BCA ASSESSMENT REPORT

**Lot 201, ESR Horsley Logistics Park
Horsley Park**

**Prepared For:
ESR Australia**

Date: 29 April 2021

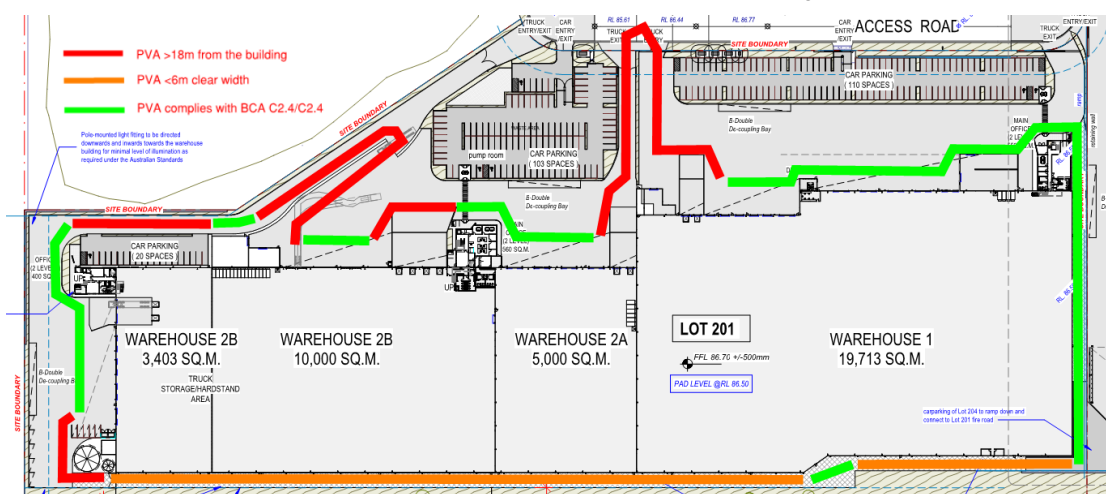
Comments: The proposed building does not comply with the provisions of C2.4 and thus the following non-compliance areas identified on the site plan are required to be addressed as a Performance Solution by the Fire Safety Engineer:

- The furthest part of the vehicular access path is greater than 18m from the external wall along in the locations shown in red below.
- The perimeter vehicular access on the southern side of the building is less than 6m wide.

Note 1: The driveways providing vehicular perimeter access must be designed with adequate loading capacities to withstand a fire truck and the gradients of the ramps should take into consideration to the FRNSW Policy 4 Vehicular Access Guideline.
